# Service Bulletin

Bulletin No. 2010-73  
CMD 2010-13

## Official Recall Notification Under the U.S. Federal Boat Safety Act

## Replacement of the Core Wire of the Intermediate Shift Cable on Mercury MerCruiser Alpha and Bravo Sterndrives

**Green or blue dot on the end of the core wire indicates a corrected core wire**

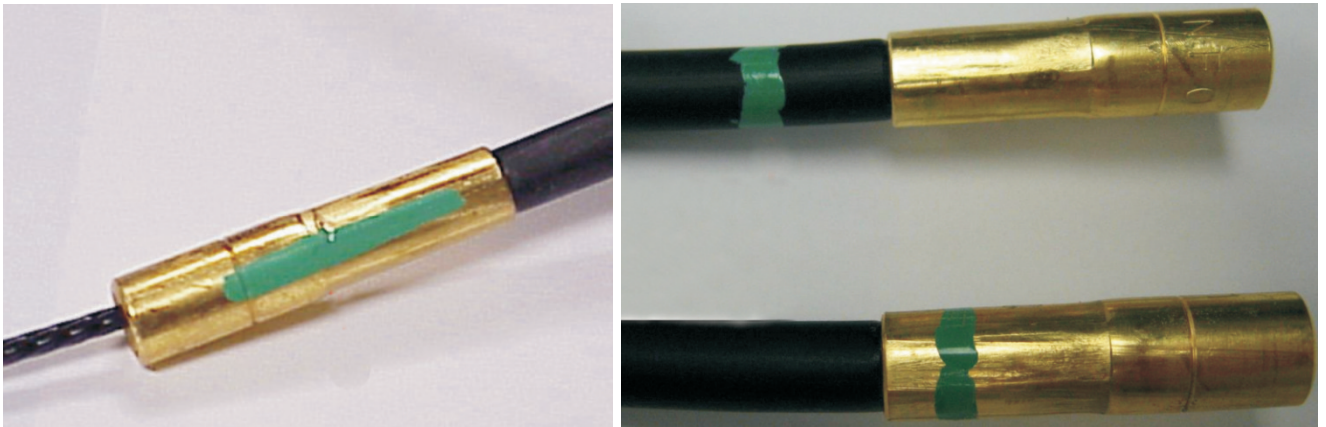
Cables in transoms within the affected serial number range or cables within the date codes have been repaired if they are marked with a green or blue paint dot on the cable end. Corrected cables are now being marked with a green paint stripe on the barrel of the cable jacket or a stripe of green tape around the outside of the cable housing at the engine end of the cable. If this green marking is present, core wire replacement is not necessary. Some cables did not receive the paint mark on the outer cable. If the paint dot is present on the core wire end but not on the outer cable, the cable is still good. Add a mark to the outer cable and submit a claim for inspection without replacement.

**Various markings to indicate a corrected cable**

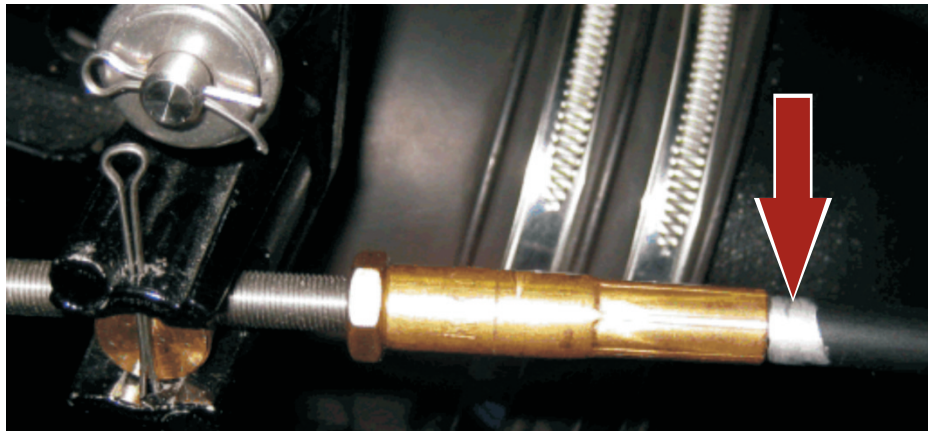
Corrected cables have been marked on the outer housing at the engine end to signify that the inner core wire has been changed.

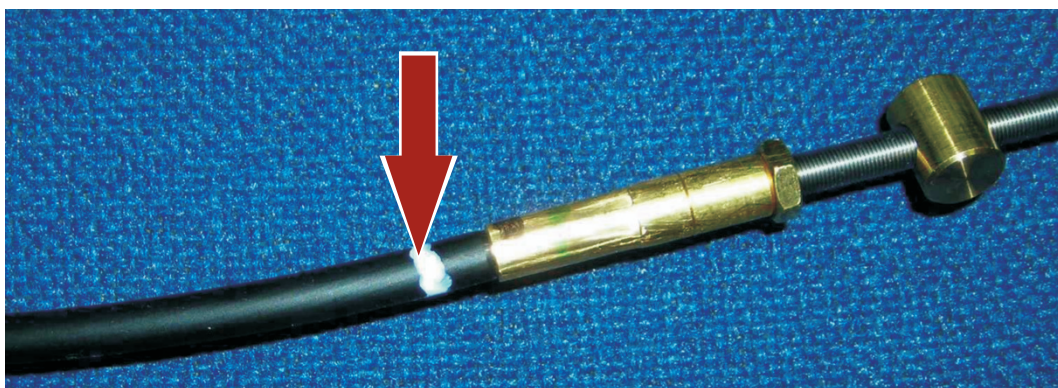
Boat builders have been painting a silver stripe around the cable behind the brass ferrule at the engine end of the cable to signify that the inner core wire has been changed. Regardless of the color used on the outer cable housing, the inner core wire is identified with a green or blue paint dot on the end.

**Dealers:** Mark the outer cable at the engine end as shown with a white paint line.
